MANDATORY BULLETIN - *draft*

No BO-16/07 MDM-1 FOX/ MDM-1P FOX-P

CONCERNS: Canopy hinge

WORKING INSTRUCTION INSPECTION & REPAIR OF CANOPY HINGE ASSEMBLY

Dwg No B2-14.15.00

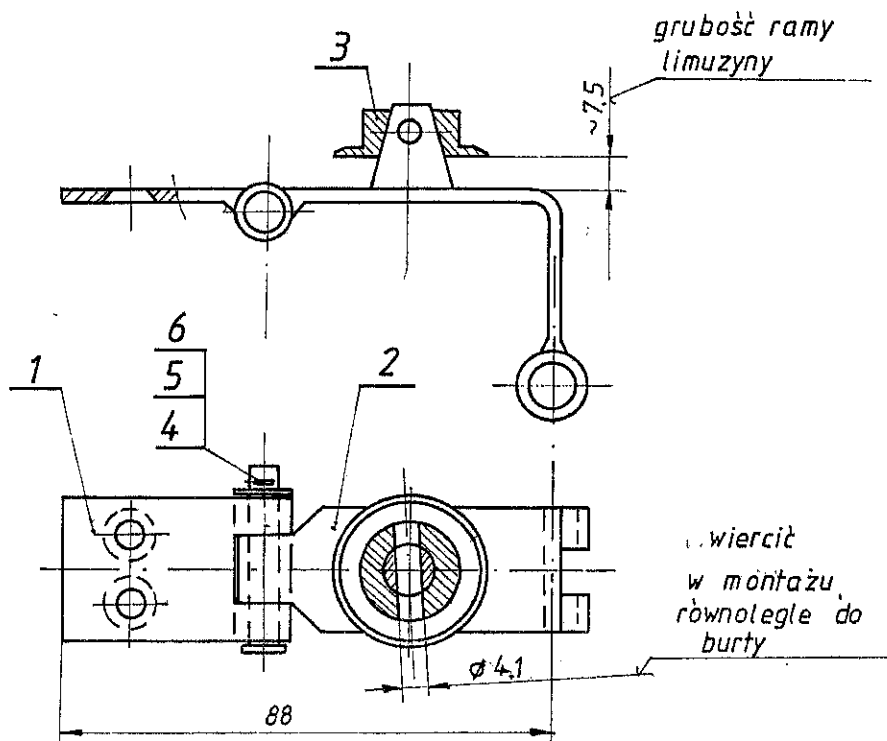
At the glider inspection, on several (4+1) MDM-1 FOX gliders, the cracks in the area of welded joint between the attachment cone and hinge plate (Dwg. No. B2-14.15.20) have been found at the canopy gas-spring attachment points on front&rear cockpit canopy.

Action 2. (a) If evidence of cracks in welded joint area has been detected at the hinge, the attachment cone must be re-welded to hinge plate – as per instruction in the Enclosure No 1 to this Bulletin.

1 Action 2A – re-welding of damaged hinge

1. Disassemble the hinge from canopy
 2. Clean the whole welded joint thoroughly
 3. Verify the detail against next/ other mode cracks and damages
 4. Re-weld the cracked area with thorough penetration, extending the area of penetration slightly beyond the edge of visible crack
 5. Detail hardening operation/ 880 deg C – oil
 6. Detail tempering operation/ 540 deg C – water or oil / 27-33 HRC hardness
 7. Clean the welded area from scale
 8. Protect the detail with anti-corrosion paint.
- NOTE: do not paint the openings and conical surface**
9. When assembling, cover the non-painted surface with grease
 10. As a result of hardening, the increased clearance at opening- and conical mating surface may appear.
 11. Welding by TIG inert gas method

2. Action 2B – replacement of damaged hinge with new one

In this case, replacement of affected hinge with new one – simple operation of metal element bonding to composite structure with subsequent curing

- welding wire – same as for the 4130 steel (Polish spec. Sp20G1H1M)
- welding electrode - 2-3 mm diameter
